PREDETERMINATION SETTLEMENT AGREEMENT

CP# 09-19-74021 HUD # 07-19-2822-8

<u>Subject Property</u>

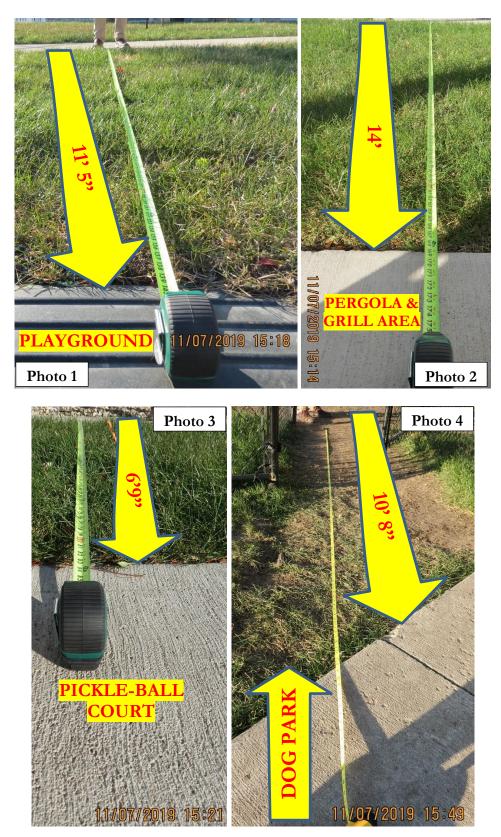
2) The pergola, grill, pickle-ball court, and playground are located south and the dog park is adjacent to the northwest of the apartment-unit building. The route from the closest sidewalk to each of these common areas was measured as indicated in the following captioned sections from the site plans:

The route to these common areas includes grassy surfaces that are not "stable, firm, and slip resistant," as required by Section 4.5.1 of the ANSI 1986, that was previously quoted.⁹ Therefore, the pergola, grill, pickle-ball court, playground, and the dog park are not accessible to persons who use a wheelchair for mobility.

2) Respondent Lloyd Associates will install concrete and/or stone paver sidewalks to the common areas included in the report to connect them to the existing adjacent sidewalk so these areas will be on an accessible route.

2) ICRC agrees with Respondent Lloyd Associates' proposal to install concrete and/or stone paver sidewalks to the common areas included in the report to connect them to the existing adjacent sidewalk so these areas will be on an accessible route.

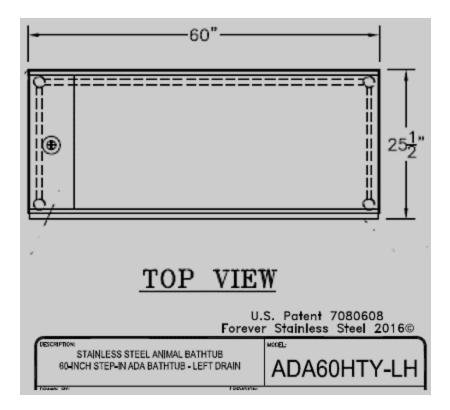
3) The Guidelines require common access areas, such as the dog-wash station to be accessible by tenants who use a wheelchair as a mobility assistive device.¹⁰ There is enough clear floor space in the front of the dog-wash station for tenants using wheelchairs to make a parallel approach. The spray valve is located directly above the right side of the tub portion of the dog-wash station. Therefore, the tub creates an obstruction. The horizontal depth of the tub is 25 ½", which exceeds the 24" maximum depth allowed by ANSI 1986.¹¹ The height of the spray valve handle was measured at 60", which exceeds 46"-maximum allowed by ANSI 1986, when an obstruction with a depth of no greater than 24" is present.

ICRC Investigators took the following photograph (see Photo 6) to document their height measurement:

The depth of the tub and height of the spray valve render the dog-wash station inaccessible and unusable by tenants utilizing a wheelchair.

3) Respondent Lloyd Associates state they have taken the spray valve off the wall-mounted hook and placed it on the tub section of the dog-wash station, and removed the wall-mounted hook to make the spray reachable.

3) ICRC has reviewed the photographs submitted by Respondent Lloyd Associates and agrees with their claim that these photographs show they have taken the spray valve off the wall-mounted hook and placed it on the tub section of the dog-wash station, and removed the wall-mounted hook to make the spray compliant with the reachability requirements. ICRC does not require further action from Respondent Lloyd Associates or any other Respondents to correct this deficiency.

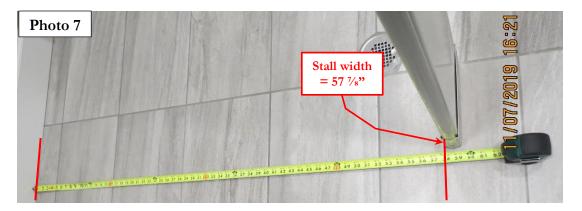
4) In accessible toilet stall the men's bathroom – which is located near the leasing office – the width of the clear floor space was measured at 57 $\frac{7}{8}$ ", which is less than the 60"-minimum width required in the Manual.

ICRC Investigators took the following photographs (see Photos 7 and 8) to document their measurement:

If the stall wall partition had been installed as designed, this bathroom stall width would have been compliant with the minimum width requirement for accessible stalls. However, as it was installed, this bathroom stall is too narrow, which makes it unusable by persons who use a wheelchair for mobility.

4) Respondent Lloyd Associates state they have moved the partition wall in the men's bathroom that is adjacent to the leasing office to increase the width of the clear floor space to no less than the required 60"-minimum. Respondent Lloyd Associates submitted photographs to document compliance for this feature.

4) ICRC has reviewed the photographs submitted by Respondent Lloyd Associates and agrees with their claim that these photographs show they moved the partition wall in the men's bathroom that is adjacent to the leasing office to increase the width of the clear floor space to no less than the 60"-minimum in Title III of the ADA, and is therefore compliant with the accessibility requirements. ICRC does not require further action from Respondent Lloyd Associates or any other Respondents to correct this deficiency.

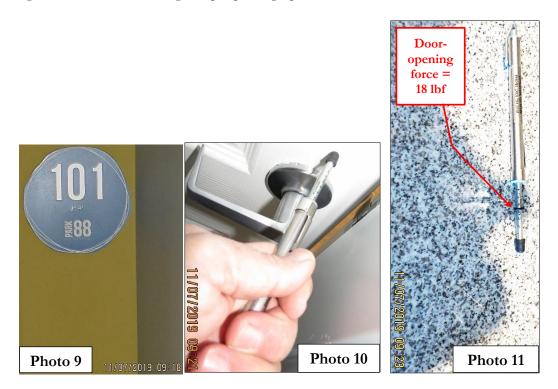
The doors listed in the table above exceed the applicable maximum limits allowed by ANSI for both interior swinging doors that are fire rated and those that are not fire rated.

ICRC Investigators took the following sample photographs at Unit 101 to document their measurement:¹³

These doors require too much force to open, which makes them unusable for persons with disabilities who have diminished strength to push or pull.

5) Respondent Lloyd Associates have adjusted the self-closers on the doors in the table on page 14 of the current agreement such that the force required to open these doors does not exceed the 5 lbf-maximum for doors that are not fire-rated and the 15 lbf-maximum for fire-rated doors. Respondent Lloyd Associates submitted photographs to document compliance for this feature.

5) ICRC has reviewed the photographs submitted by Respondent Lloyd Associates and agrees with their claim that these photographs show they adjusted the self-closers on the doors in the table on page 14

of the current agreement such that the force required to open these doors does not exceed the 5 lbfmaximum for doors that are not fire-rated and the 15 lbf-maximum for fire-rated doors. ICRC does not require further action from Respondent Lloyd Associates or any other Respondents to correct this deficiency.

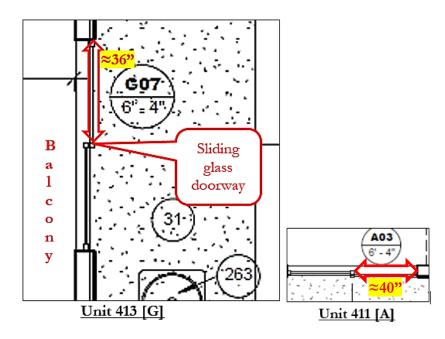
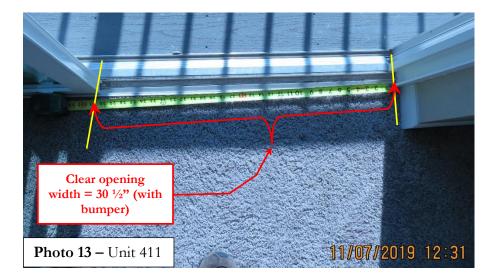
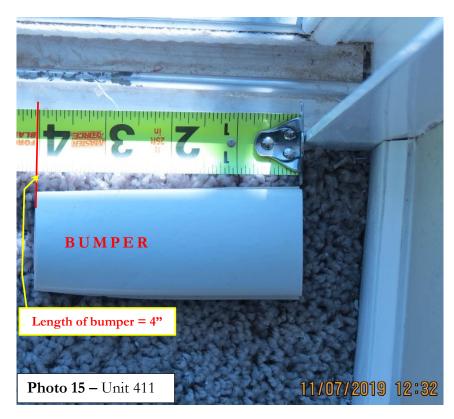
7) The plans submitted by Respondents include scaled drawings of the dwelling units. The following relevant portions of the construction plans for Units 413 [G], and 411 [A] indicate how wide the doorways were designed to be:¹⁴

ICRC Investigators took measurements of the clear opening width at the secondary doorways within all inspected units. The clear opening width of the doorways that were narrower than the 31 ⁵/₈"-minimum required are listed in the following table, along with the corresponding clear opening widths of these doorways as based on the construction plans:

ICRC Investigators took the following sample photographs (see Photos 13, 14, 15, and 16) to document their measurements:

The doorways reported in the table above were designed to be sufficiently wide to be compliant with the 31 ⁵/s"-minimum width requirement. However, as built, the clear opening widths of these secondary doorways are less than the 31 ⁵/s"-minimum width requirement. Therefore, these doorways are too narrow, rendering them unusable by persons using wheelchairs.

7) Respondent Lloyd Associates state they have replaced the current bumpers with shorter ones to increase the clear opening width – of the doorways at the balconies of the units reported on page 15 of the current agreement – to no less than the 31 $\frac{5}{8}$ "-minimum that is required for secondary doorways. Respondent Lloyd Associates have submitted photographs to document compliance for this feature.

7) ICRC has reviewed the photographs submitted by Respondent Lloyd Associates and agrees with their claim that these photographs show they replaced the current bumpers with shorter ones to increase the clear opening width – of the doorways at the balconies of the units reported on page 15 of the current agreement – to no less than the 31 $\frac{5}{8}$ "-minimum that is required for secondary doorways. ICRC does not require further action from Respondent Lloyd Associates or any other Respondents to correct this deficiency.

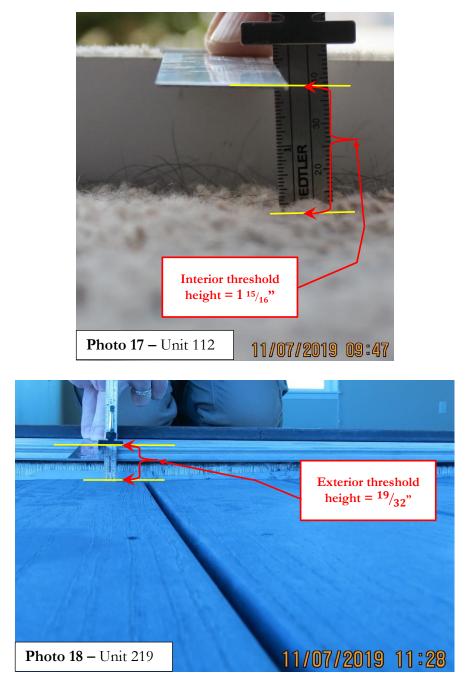
8) The table below lists the measurements obtained for the interior and exterior threshold heights at the sliding glass doorway onto the exterior surfaces of the balconies for all inspected units and the distance that the exterior surface is below the finished interior floor surface, which is calculated by subtracting the interior threshold height value from the exterior threshold height value. All interior threshold values are reported as numerical values because they exceed the ¹/₄"-maximum height. However, if the resulting difference between interior and exterior threshold meets the above-stated requirements, they are labeled as "Compliant." All values in the following table are expressed in inches.

All of the interior threshold heights listed in the table above exceed the $\frac{1}{4}$ "-maximum allowed for thresholds without beveling.¹⁵ The exterior pervious surface adjacent to the secondary balcony entrance in Units 219 and 413 was measured to be no less than $\frac{22}{32}$ " below the interior finished floor surface, which exceeds the maximum. The exterior pervious balcony surfaces for these two unit types are below the interior finished floor surface by more than the $\frac{1}{2}$ "-maximum that is allowed by the Guidelines.

ICRC Investigators took the following sample photographs (see Photos 17 and 18) to document their measurements:

The plans submitted by Respondents did not include any instructions or diagrams about the threshold heights of doorways. The reported thresholds are too high, rendering them unusable by persons using wheelchairs.

8) Respondent Lloyd Associates will purchase and store an adequate stock of accessible ramps for both interior and exterior rises of the units in listed in the table on page 18 of the current agreement. Respondent Lloyd Associates will advise potential residents or customers who inquire about and are shown units that Park88 has ramp risers for both the interior and exterior doorway thresholds which comply with the FHA.

8) ICRC agrees with Respondent Lloyd Associates' proposal to install accessible ramps at the interior and exterior sides of the thresholds of the doorways at the balconies in units listed in the table on page 18 of the current agreement. However, ICRC will require the ramps be installed at all units with non-compliant interior thresholds without first requiring tenants to request the ramps. ICRC will allow tenants to refuse the installation of the ramps for the duration of their tenancy. However, ICRC will require that the ramps be reinstalled at units where they were refused by the previous tenant, and before the unit is shown to the next tenant. ICRC will allow Respondent Lloyd Associates to offer tenants the option to refuse the installation of the ramps, but only for three years from the date of the Closing Letter from ICRC. ICRC will require Respondent Lloyd Associates to cease from offering tenants the option to refuse this retrofit after the aforementioned three-year period.

Photo 22 - Unit 128

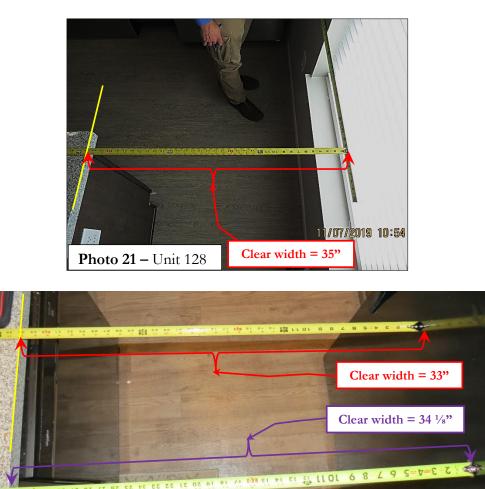
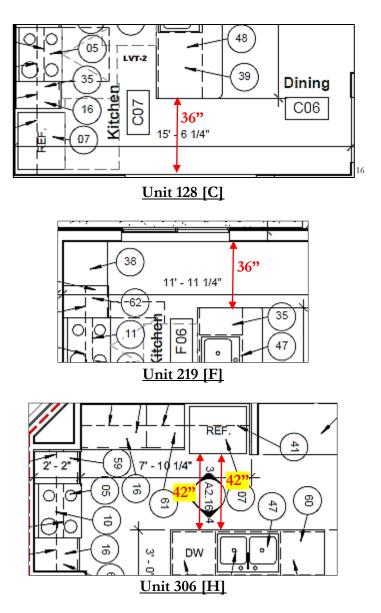
9) ICRC Investigators measured the clear width of the path between the refrigerator and opposing fixtures; and between the countertop at the kitchen island and the opposing wall. The measurements that are out of compliance with the requirements previously cited are listed in the following table:

ICRC Investigator took the following sample photographs (see Photos 21 and 22) to document their measurements:

Respondents submitted plans for all units. The plans for the kitchen in the units described in the last paragraph are shown below:

As indicated in the scale drawings above, the clear width of the paths between (i) countertop at the kitchen island and the opposing wall was designed to be 36" in Units 128 and 219; and (ii) between the refrigerator and opposing countertop/appliance was designed to be 42" in Unit 219. If the kitchens in all three units had been built as they were designed, they would have been compliant. However, as built, these paths are too narrow rendering these kitchens unusable by persons who use a wheelchair.

Although the design of the kitchen is compliant for Units 128 and 219, the fact that it was designed to only meet the 36"-minimum clear width requirement, it does not allow for the typical deviation from plans – referred to as "construction tolerance" – that is commonly observed upon completion of the construction. If no allowances are made for construction tolerances during the design phase of property development, the chances of non-compliance during the final construction phase increase.

9) Respondent Lloyd Associates are currently exploring the manner in which they will retrofit the kitchens of Units 128 and 219 – and similar units – to increase the clear width of the path between the countertop on the kitchen island and the opposite wall to no less than the required 36"-minimum width.

Respondent Lloyd Associates will replace the current refrigerator in the kitchen of Unit 306 – and in similar units – with a counter-depth refrigerator to increase the width of the path between the refrigerator and opposing features to no less than the 40"-minimum required.

9) ICRC concurs with Respondent Lloyd Associates' proposal to retrofit the kitchens of Units 128 and 219 – and similar units – to increase the clear width of the path between the countertop on the kitchen island and the opposite wall to no less than the required 36"-minimum width. ICRC will require Respondent Lloyd Associates to submit their proposed retrofit to correct this deficiency within 14 days from the date of the Closing Letter from ICRC to verify whether the selected type of retrofit is approved. ICRC will respond to the proposed retrofit within three days from the date it is submitted via email.

ICRC agrees with Respondent Lloyd Associates proposal to replace the current refrigerator in the kitchen of Unit 306 – and in similar units – with a counter-depth refrigerator to increase the width of the path between the refrigerator and opposing features to no less than the 40"-minimum required.

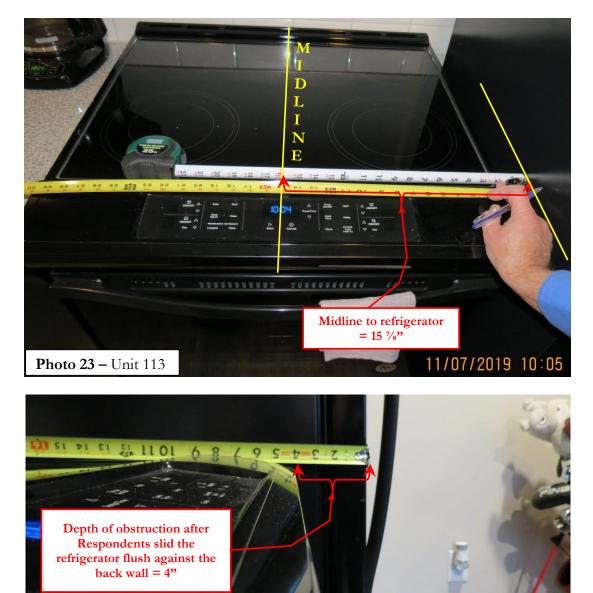
However, ICRC Investigators measured the distance from the midline of the kitchen sink to the adjacent wall at $14 \frac{1}{8}$ ", which is less than the 15"-minimum required for the forward approach that is available because the base cabinets are compliant with the requirements for removable cabinets.

ICRC Investigators took the following photograph (see Photo 23) to document their measurement:

Therefore, this sink is unusable for persons who use a wheelchair for mobility because the midline of the sink is closer to the adjacent wall as allowed by the 15"-minimum clearance that is required for a forward approach.

10) Respondent Lloyd Associates will allow Unit 411 and seven additional units – which have similarlydesigned kitchens where the midline of the sink is less than the 15"-minimum required clearance from the adjacent wall – to remain as they are without further modification for the following reasons: (1) these sinks are only less than 1" less than the 15"-minimum required clearance; and (2) the countertops by the kitchen sinks are made of granite, which is extremely expensive to modify, especially given the very slight variation with the accessibility requirements.

10) ICRC disagrees with Respondent Lloyd Associates' proposal to allow Unit 411 and seven additional units – which have similarly-designed kitchens where the midline of the sink is less than the 15"-minimum required clearance from the adjacent wall – to remain as they are without further modification. Taking no action to correct this deficiency would allow this feature to remain inaccessible in violation of the accessibility requirements from the ICRA and the FHA.

However, ICRC acknowledges (1) the non-compliant kitchen sinks are less than 1" away from complying with the 15"-minimum required clearance, which is expected to have a limited impact on the accessibility of these kitchen sinks for tenants who use a wheelchair for mobility; and (2) the significant expense of modifying the granite countertops adjacent to these kitchen sinks.

Therefore, ICRC will require Respondent Lloyd Associates to (1) provide written notice to tenants, prior to entering into a lease agreement, that prominently advises the tenant of their option to have management - at no cost to tenant - relocate the sink faucet further away from the wall such that the midline of the sink faucet is no less than the required 15" minimum from the adjacent wall to increase the clear floor space if they need it to be able to use the sink; and (2) adhere a permanent placard, which is readily visible and at a prominent location, on the inside of the cabinet door under the sink which re-states the same message regarding their rights to have the sink retrofitted as described above at no cost. ICRC will require Respondent Lloyd Associates to complete this retrofit within 14 days from the date of the written request submitted by a tenant.

Photo 24 – Unit 113

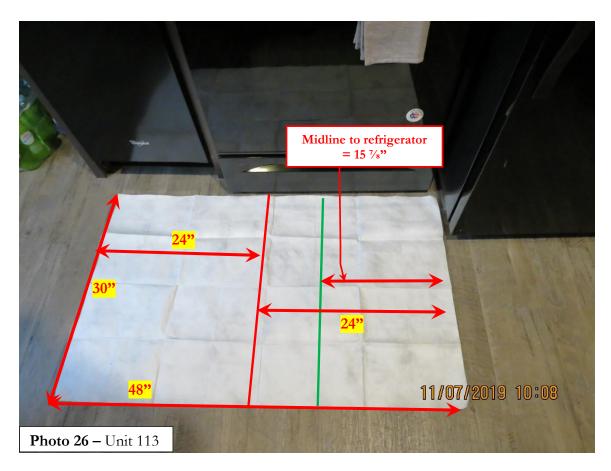
11) ICRC Investigators measured the clearance from the midline of the range to the adjacent refrigerator in Unit 113 [L] at 15 ⁷/₈", which is less than the 24"-minimum clearance that is required for a parallel approach by someone in a wheelchair. The parallel approach is the only possible approach due to the absence of the knee space that would be required for a forward approach.

ICRC Investigators took the following photographs (see Photos 24, 25, and 26) to document their measurements, which include a photo showing the measured clearance via tape measured, and via a 30"-by-

The plans submitted by Respondents include scaled drawings of the dwelling units. The relevant portions of the drawings for an ANSI Type A unit and an ANSI Type B unit are shown below:¹⁷

Based on the scaled drawings above, the midline of the range was designed to be about 16" away from the adjacent opposing countertop. The midline of the range was measured to be $15 \frac{7}{8}$ " away from the adjacent refrigerator in Unit 113 – as previously reported – which is less than the 24"-minimum required for a

parallel approach by someone using a wheelchair. As designed and built, the kitchen in Unit 113 is unusable because the midline of the range is too close to the adjacent refrigerator to allow tenants using wheelchairs to make the required parallel approach.

11) Respondent Lloyd Associates state they pulled the range forward away from the wall in Unit 113 so that refrigerator no longer protrudes into the required 30"-by-48" clear floor space centered on the range to allow for the required parallel approach to the range by a tenant using a wheelchair. Respondent Lloyd Associates have submitted photographs to document compliance for this feature.

11) ICRC has reviewed the photographs submitted by Respondent Lloyd Associates and agrees with their claim that these photographs show they pulled the range forward away from the wall in Unit 113 so that refrigerator no longer protrudes into the required 30"-by-48" clear floor space centered on the range to allow for the required parallel approach to the range by a tenant using a wheelchair. ICRC does not require further action from Respondent Lloyd Associates or any other Respondents to correct this deficiency.

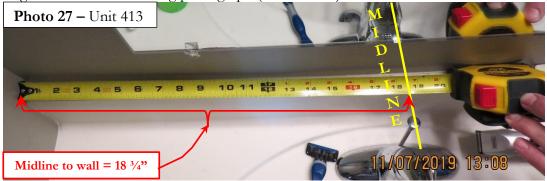
12) In Unit 413 [G], the midline of the sink was measured to be $18 \frac{3}{4}$ " from the adjacent wall, which is less than both the 24"-minimum requirement when the base cabinets are not removable, which was verified by Respondents.

ICRC Investigators took the following photograph (see Photo 27) to document their measurement:

Respondents submitted scaled construction plans, which include the following portion indicating the design for the bathroom in Unit 413:

Therefore, the bathroom sink in Unit 413 would be compliant with if the sink had been installed as designed. However, as built, the midline of the bathroom sink in this unit is too close to the adjoining wall because it is less than 24" – which renders it unusable by persons using wheelchairs

12) Respondent Lloyd Associates will replace the current bathroom sink countertops with offset countertops in Unit 413 such that the midline of the sink will be no less than the 24"-minimum required because the base cabinets are not removable.

12) ICRC agrees with Respondent Lloyd Associates' proposal to replace the current bathroom sink countertops with offset countertops in Unit 413 such that the midline of the sink will be no less than the 24"-minimum required.
